Product Change Notification

Change Notification #: 851912-00

Change Title: Select Intel® Ethernet Network Adapter E810-CQDA2

Change Detail: Anti Counterfeit Label Removal

Label

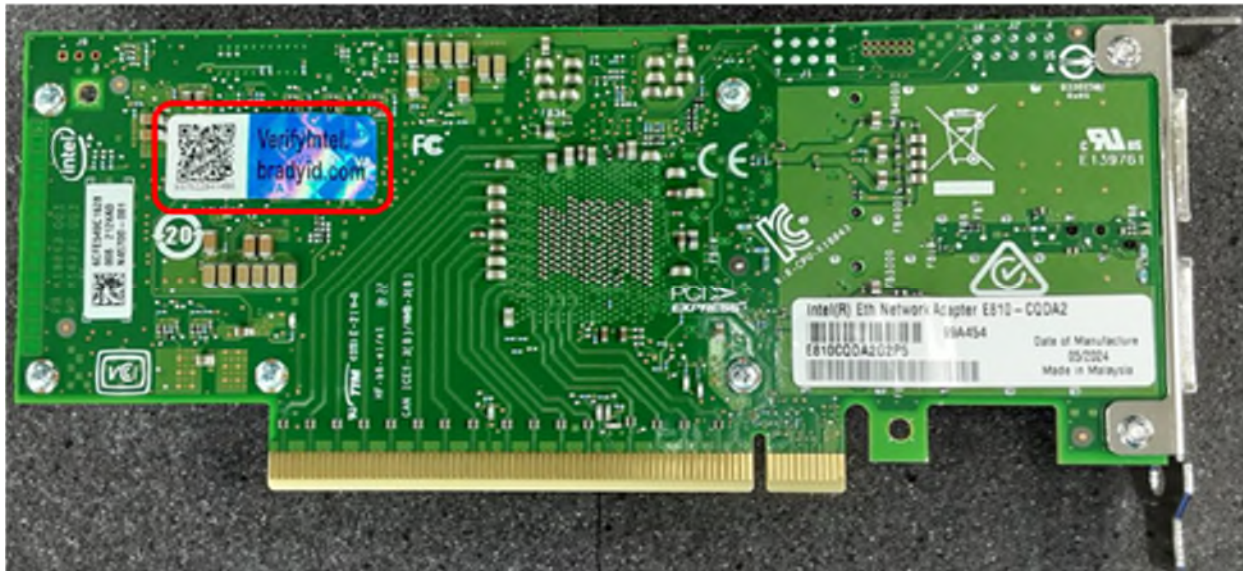
The following Anti Counterfeit Label (K41510-001) will be removed from the secondary side of these SKUs' boards:

Due to the board's design, which includes numerous components, lead protrusions, regulatory markings, and traces that cannot be covered, there is insufficient space for the label to remain securely attached to the product. Consequently, the label may become loose and, in some instances, detach from the board. As a result of these changes, the Printed Board Assembly (PBA) and Top Assembly (TA) numbers will be dash-rolled as indicated in the affected products table within this PCN notice. If the PBA/TA numbers are printed on any product or box labels, they will also reflect the PBA/TA number update.
